REGULATION No. 37
(Filament lamps)

Provisions for new filament lamp categories

Proposal for draft Supplement 31 to the 03 series of amendments to regulation no. 37

Sheets H15/1 to 5, amend to read:

" **CATEGORY H15** **Sheet H15/1**

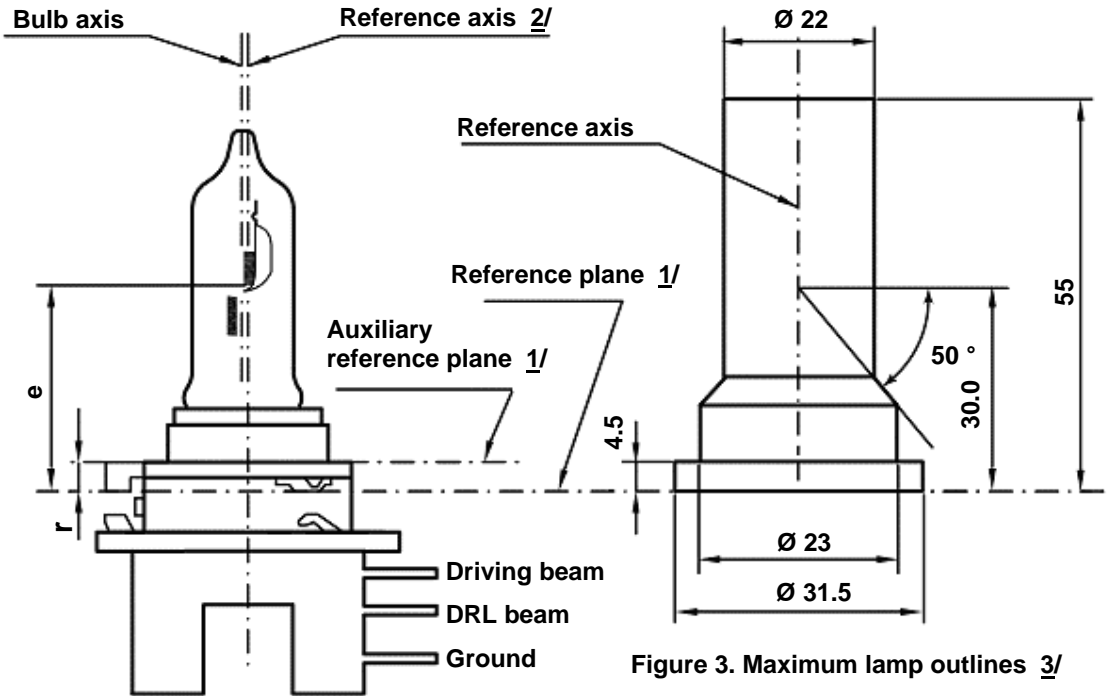
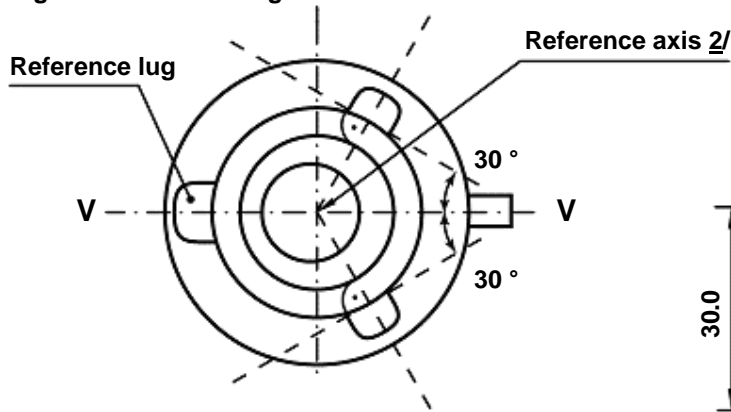
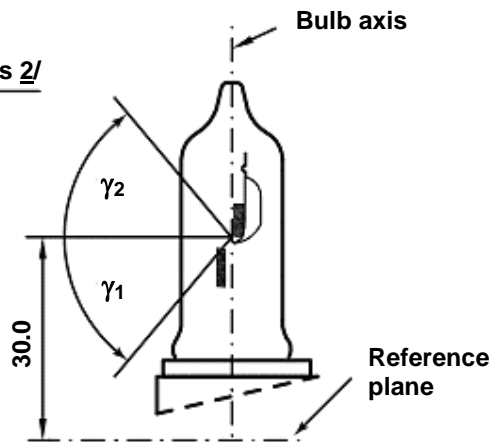
- 2/ The reference axis is perpendicular to the reference plane and crosses the intersection of the two perpendiculars as indicated in figure 2 on sheet H15/1.
- 3/ Glass bulb and supports shall not exceed the envelope as indicated in figure 3. The envelope is concentric to the reference axis.
- 4/ Glass bulb shall be optically distortion free within the angles γ_1 and γ_2 as indicated in figure 4. This requirement applies to the whole bulb circumference within the angles γ_1 and γ_2 .

Sheet H15/2

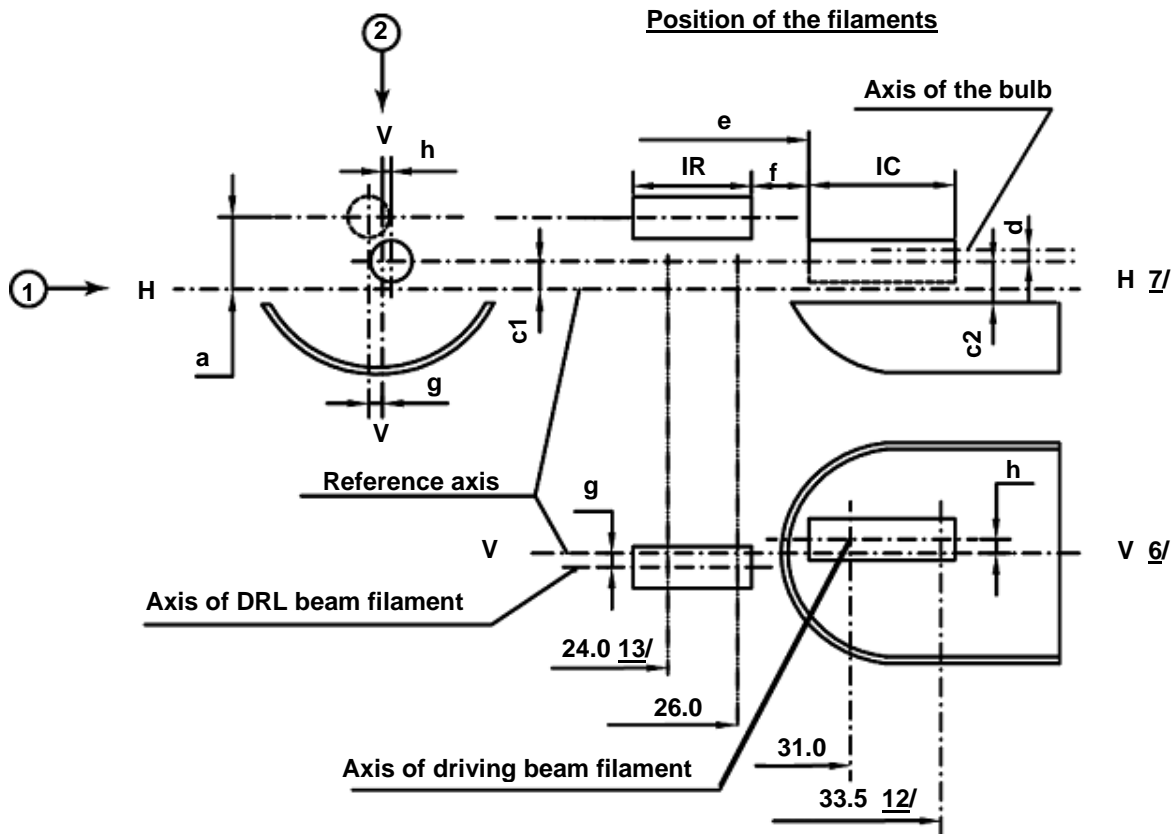
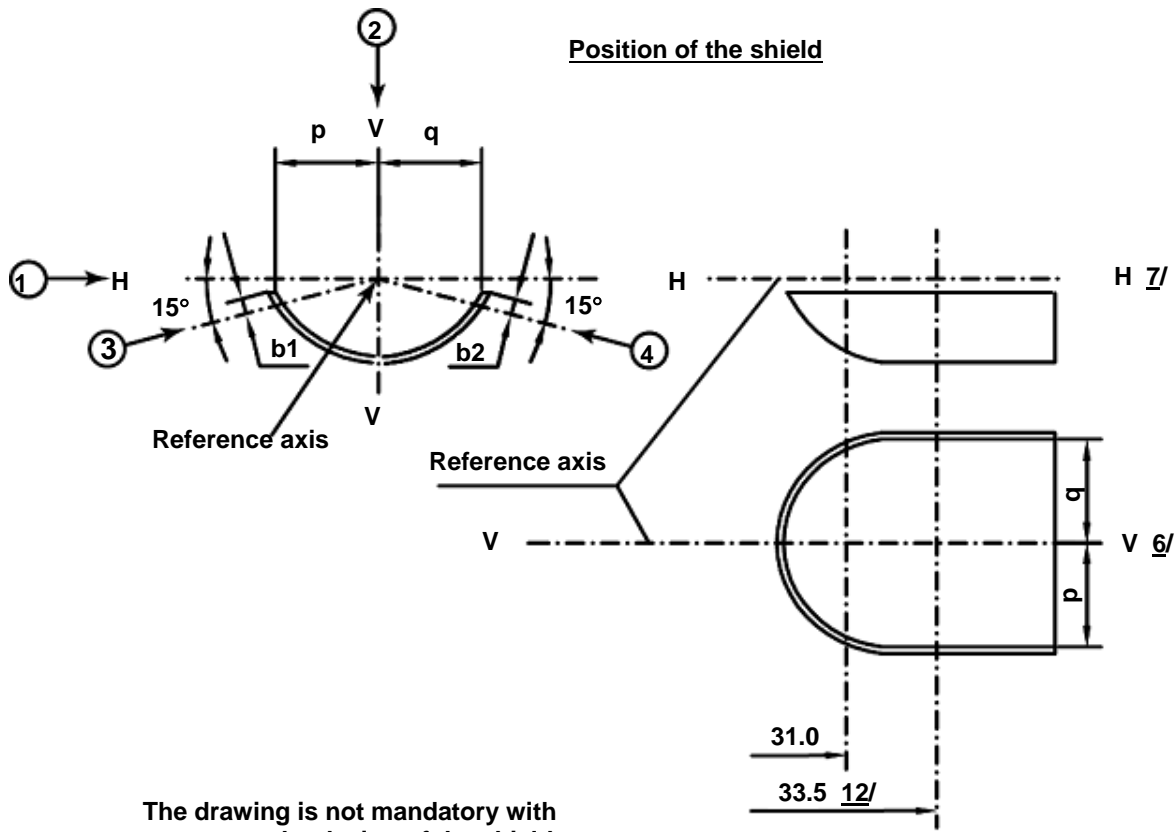
Dimensions in mm		Filament lamps of normal production				Standard filament lamp	
		12 V		24 V		12V	
e		30.0 +0.35/-0.25		30.0 +0.35/-0.25		30.0 +0.20/-0.15	
γ_1		50°min		50°min		50°min	
γ_2		50°min		50°min		50°min	
r		For details see cap sheet					
Cap PGJ23t-1 in accordance with IEC Publication 60061 (sheet 7004-155-1)							
ELECTRICAL AND PHOTOMETRIC CHARACTERISTICS							
Rated values	Volts	12 <u>5/</u>		24 <u>5/</u>		12 <u>5/</u>	
	Watts	15	55	20	60	15	55
Test voltage	Volts	13.2		28.0		13.2	13.2
Objective values	Watts	19 max.	64 max.	24 max.	73 max.	19 max.	64 max.
	Luminous flux	260	1,350	300	1,500		
		$\pm 10\%$					
Reference luminous flux at approximately 12 V							1,000
Reference luminous flux at approximately 13.2 V							1,350
Reference luminous flux at approximately 13.5 V						290

- 5/ The values indicated in the left hand columns relate to the DRL filament. Those indicated in the right hand columns relate to the driving beam filament.
